SAFETY EVALUATION BY THE OFFICE OF NUCLEAR REACTOR REGULATION
RELATED TO AMENDMENT NO. 229 TO FACILITY OPERATING LICENSE NO. DPR-28

ENTERGY NUCLEAR VERMONT YANKEE, LLC
AND ENTERGY NUCLEAR OPERATIONS, INC.
VERMONT YANKEE NUCLEAR POWER STATION

DOCKET NO. 50-271

Fig. 2: Break Mass Flow Rate vs Time

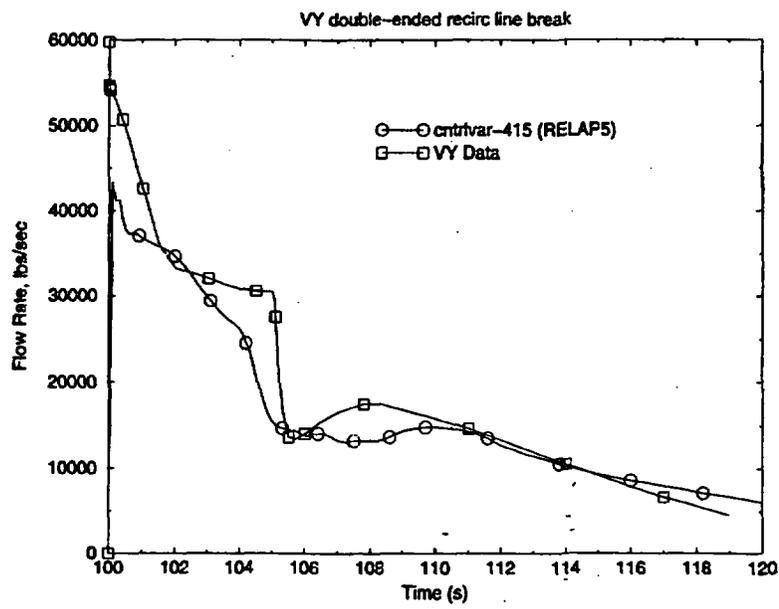
Figure 2 presents the mass flow rate from the break in the suction line. This flow rate consists of the break flow exiting both sides of the double-ended guillotine break in the recirculation line. To model the double-ended break, the break junctions are located at the exit to volume 304 and the inlet to volume 306 in Figure 1. The Henry-Fauske critical flow model in the RELAP5/MOD3 code was activated to predict the break flow. Inspection of Figures 2 and 3 shows that the RELAP5 code confirms the conservative nature of the VYNPS calculation at EPU conditions.

Figure 2.8.7-7
Void Reactivity Coefficient vs. Instantaneous Void Fraction at an Exposure of 0 GWd/t

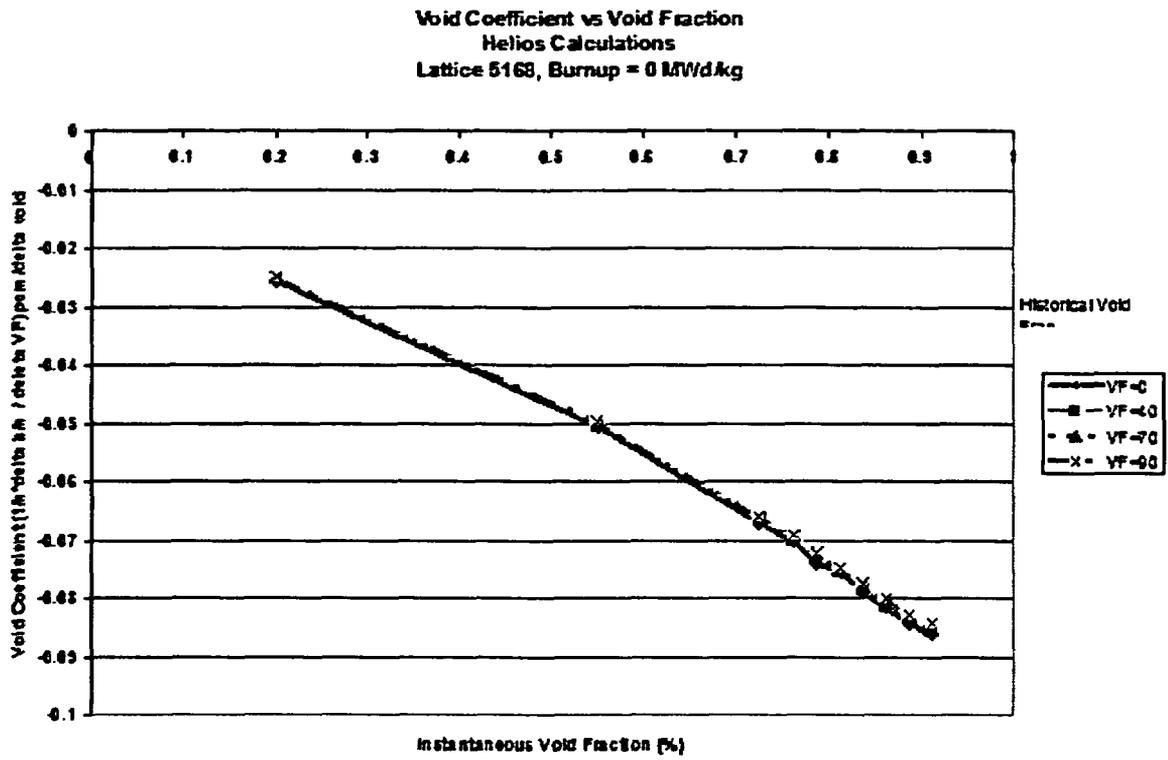
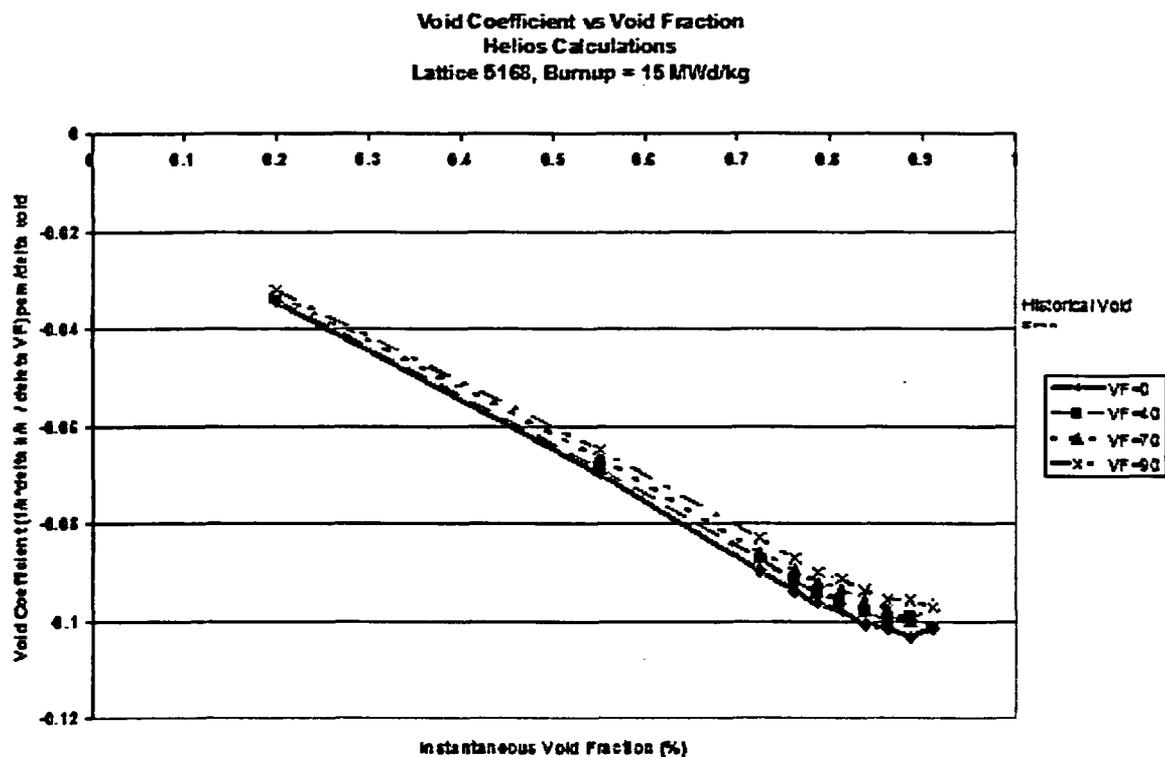
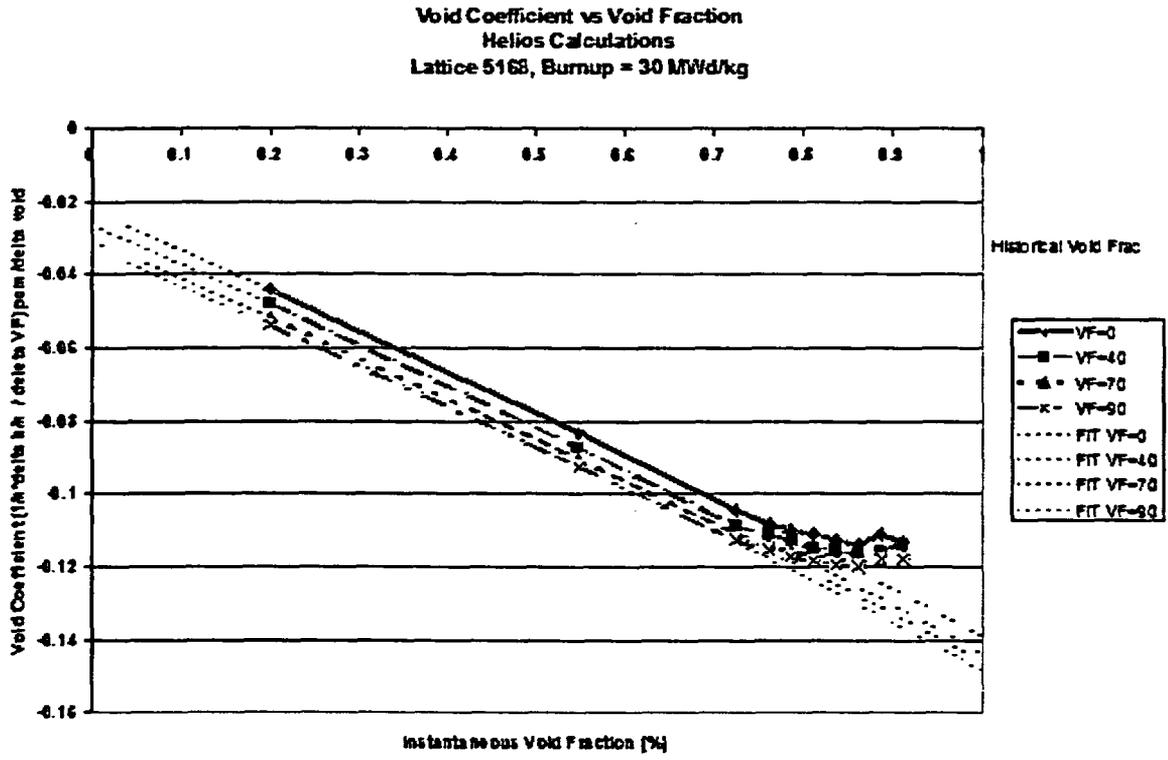
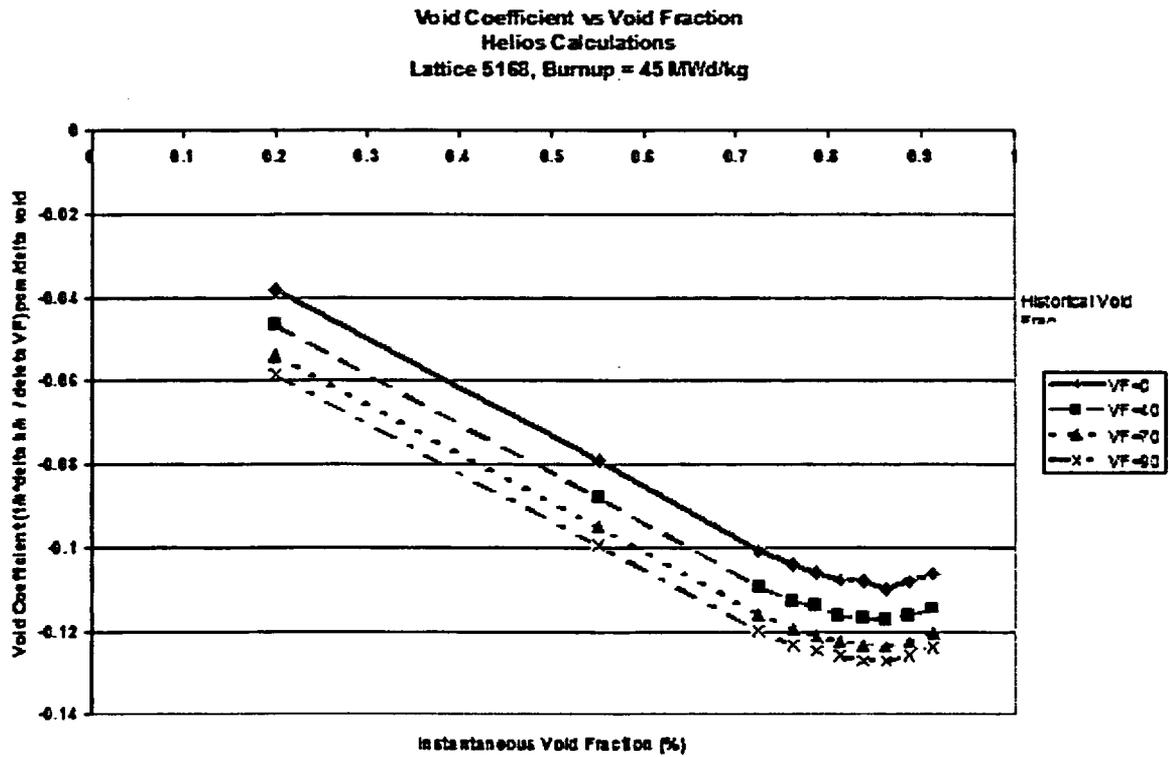
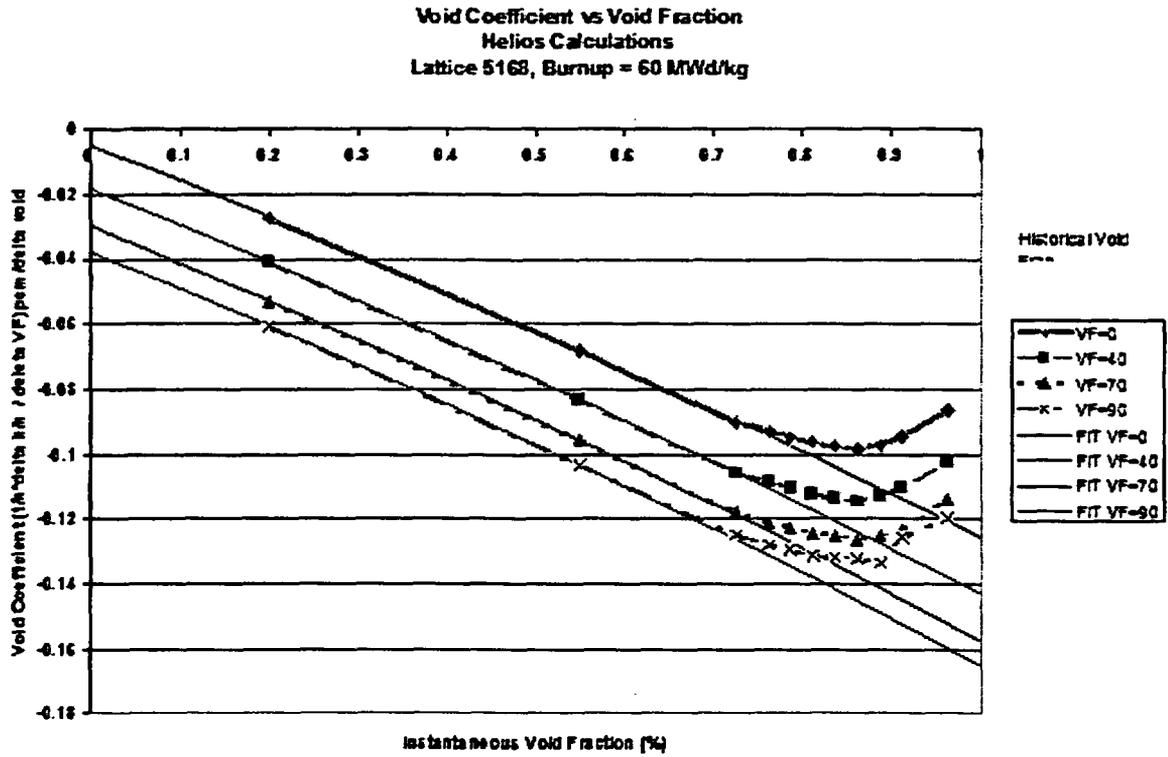
Comparisons of the void reactivity coefficients for the different void history cases and exposures are presented in Figures 2.8.7-7 through 11. Note that additional instantaneous branch points were calculated at the higher void conditions to resolve the non-linearity of the void coefficient with respect to instantaneous void fraction at high burnups. The impacts of the different void histories are evident at the higher void fractions with the increasing differences in the void reactivity profiles with increasing exposure (see Figure 2.8.7-11, for example). The difference in the profiles from that at a void history of 40% represents a potential error resulting from GE's methodology. In addition, the deviation of the void reactivity from a linear variation represents an error that results from the quadratic extrapolation used in GE's methodology. As shown in these figures, at high void fractions and high exposures the profile deviates from linear.

void branches only at 40% void history) against void reactivity coefficients calculated at different void histories with exposure. A plot showing the potential errors is presented in Figures 2.8.7-7 through 2.8.7-11. These figures show that the fitting process results in increasing errors with exposure and burnup (as previously discussed, based on the void reactivity coefficient plots). The errors for exposures of about 30 GWd/t and less are consistent with the [[]] uncertainty assumed in the ODYN analysis. However, for higher exposures at high void fractions the error increases to more than 30%.

Figure 2.8.7-19
Comparison of TGBLA-6 and CASMO-4 Kinf Values for Lattice 6996

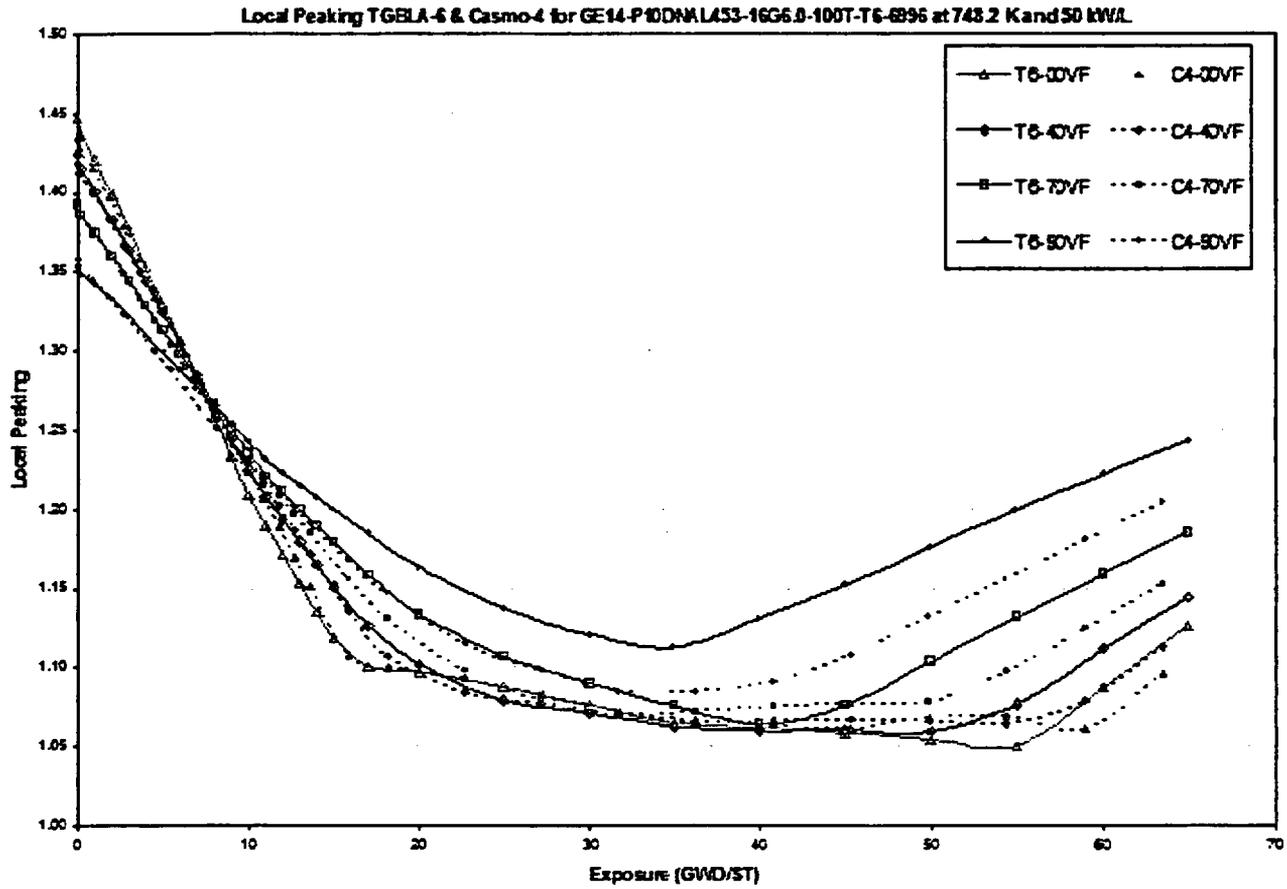
Figures 2.8.7-19 and 2.8.7-20 provides two K_{inf} vs. exposure curves for historical void fractions of 40% and 70%. The calculations were performed with an instantaneous void fraction of 0%. Therefore, the difference at high exposure is caused by differing isotopic compositions resulting from the depletion at different void histories. As these figures show, the impact of void history at high exposures is significant (greater than 5% Δk). Confirmatory analyses performed with HELIOS, presented in Figure 2.8.7-21, show a similar trend and include data for a historical void fraction of 90%.

Figure 2.8.7-22
Comparison of TGELA-6 and CASMO-4 Local Peaking for Lattices 6996

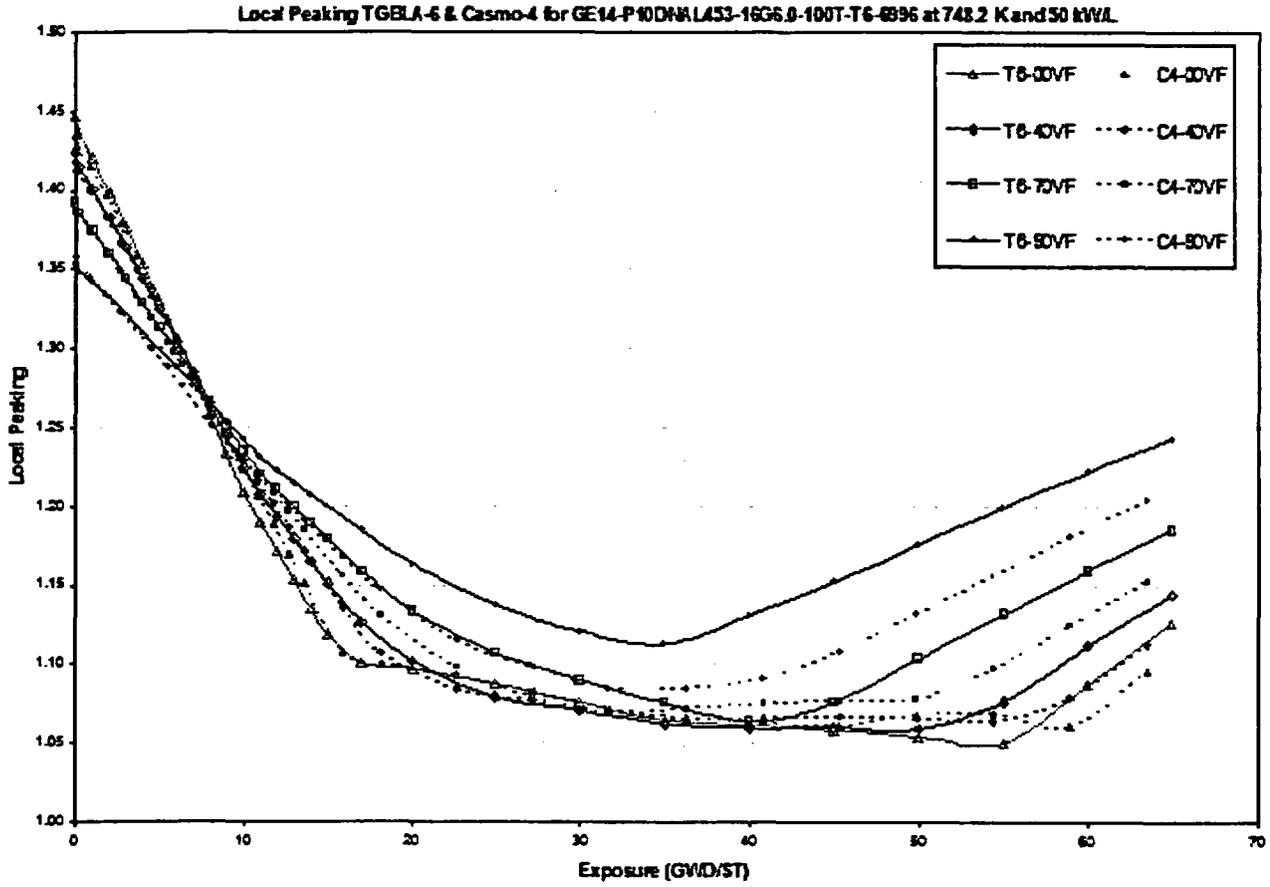
The pin peaking factor (Figure 2.8.7-22) shows good agreement at zero exposure, when the power peaking is the most significant. Differences increase with exposure resulting in several percent at burnups of 60 GWd/ST. Generally, the TGBLA-6 local peaking factors are larger than CASMO-4 and therefore will be more conservative in regards to pin exposure and LHGR. Note that at high exposures (greater than 30 GWd/ST), the power peaking is the largest for bundles with the highest void history. However, given that the power generation in this highly burned fuel is low, the net result is that the overall LHGR (a product of the region average power and the local power peaking) will be lower than that earlier in the exposure history, where the differences are smaller. However, the LHGR limit is lower at higher fuel exposures. Therefore, if spectral shift strategy is employed, as proposed in the expanded operating domains for EPU plants, with the upper nodes depleting at high void conditions and a top-peaked power distribution, both the bundle power and the pin power peaking would be high, at the most limiting kW/ft exposures.

Figure 2.8.7-23
TGBLA-6 / CASMO-4 RMS of Lattice Pin Power Peaking

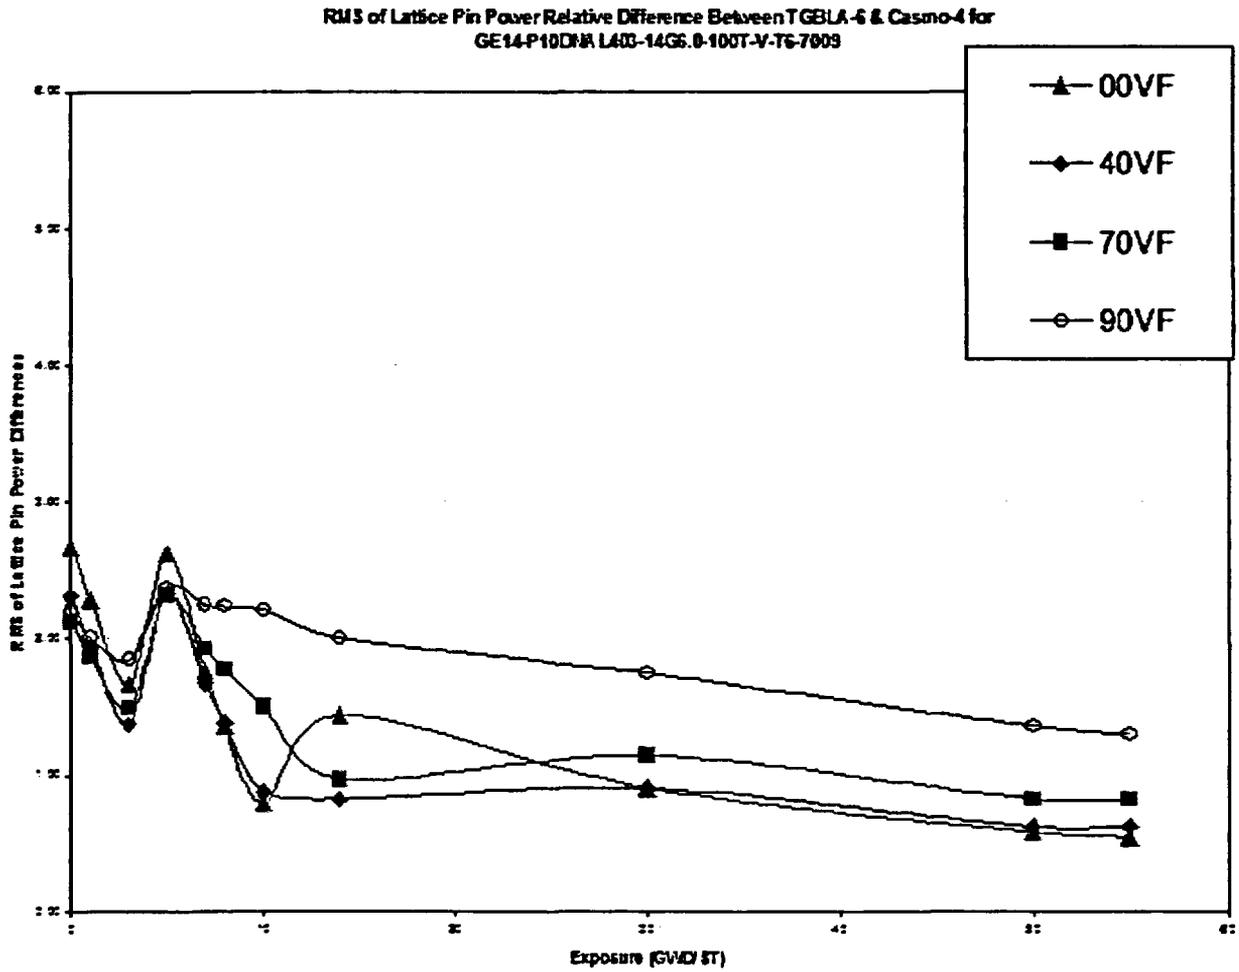
Figure 2.8.7-23 shows the root-mean-square (RMS) of the differences between TGBLA-6 and CASMO-4. The RMS error is used in development of the SLMCPR. Previous analysis comparing TGBLA-6 and MCNP (Reference 69, Enclosure 3) had shown that for a variety of lattices and exposures, that the RMS difference is $[[\quad]]$. However, in these comparisons the isotopic concentrations were taken from TGBLA and used in MCNP and, therefore, errors in depletion were not included. The results in this figure show that on a code-to-code basis that, for the lower void fractions, the RMS difference at low exposures and at high void fraction exceeds the $[[\quad]]$ RMS value, with maximum differences of about 2.5%. For the burnups above the gadolinium burnout and for lower void fractions, the differences are consistent with the $[[\quad]]$ value. Note that the results for the 90% void fraction presented in Figure 2.8.7-23 does not include potential errors caused by the quadratic fit and extrapolation used in GE's

Figure 2.8.7-28
Change in Pin Power Distribution Between 0% and 30% Bypass and Water Rod Voiding

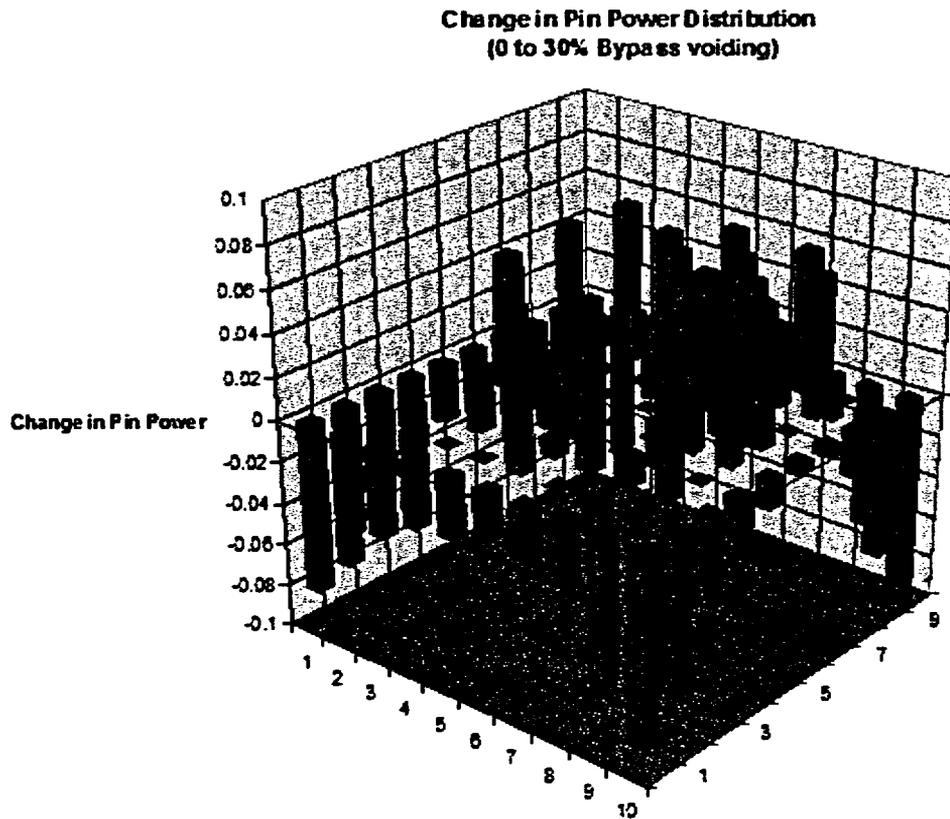
The results indicate that the power generation in the bundle is shifted away from the bypass region to the interior region of the bundle as voiding occurs. This is clearly demonstrated by plotting a difference of the power distribution between the 0% and 30% voiding cases, as is shown in Figure 2.8.7-28. The largest reduction in the pin power occurs in the corner pins, which have two faces adjacent to the bypass region. This results in a reduction of the power peaking factor since the peak pin is located near the bypass region. The reduction in the RMS of the pin power difference from the unity results presented in Table 2.8.7-3 show that the power profile becomes more uniform ("flatter") as the bypass region voids (an RMS of zero would indicate a flat power profile, while a large value indicates a high-degree of peaking). The results also show that the relative power of the peak pin also decreases (the peak does remain in the same pin for all bypass void conditions). The reduction in the lattice Kinf value indicates
